Independent Planning Commission  
Wendy Lewin &  
Dianne Leeson

## **RE: STATE SIGNIFICANT DEVELOPMENT SSD 7874**

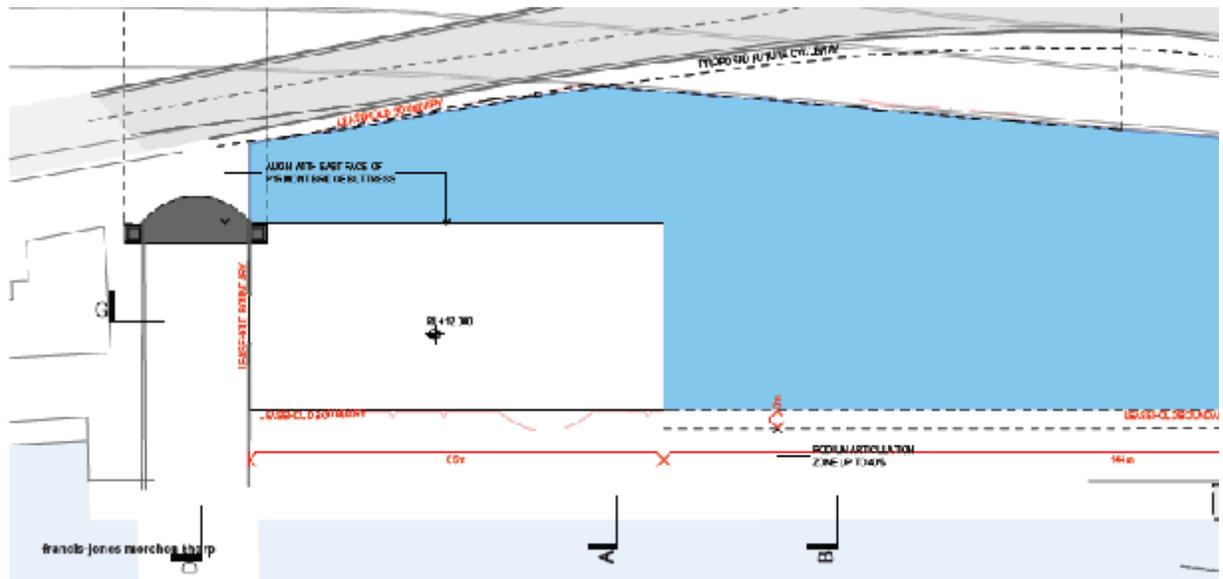
It is important to note the low rise development/valley floor principals when assessing the merit of any development in the area. The recently approved Cockle Bay development holds these principals with its approval. From the diagram below, you can see the development has been curtailed to a RL of 12

for 60 metres south of the bridge and buttresses. (Excerpt from SSD76 84)

The current Harbourside proposal obliterates these design principles with its revised proposal of a 20.1RL at the north of the site. The IPC requested Mirvac to submit a proposal showing the northern podium at a RL of 11.8 to assess the proposal on that basis. This RL brings in to the line the approved development at Cockle Bay.

Any development in northern part of the site must not be allowed at a height greater than RL11.8.
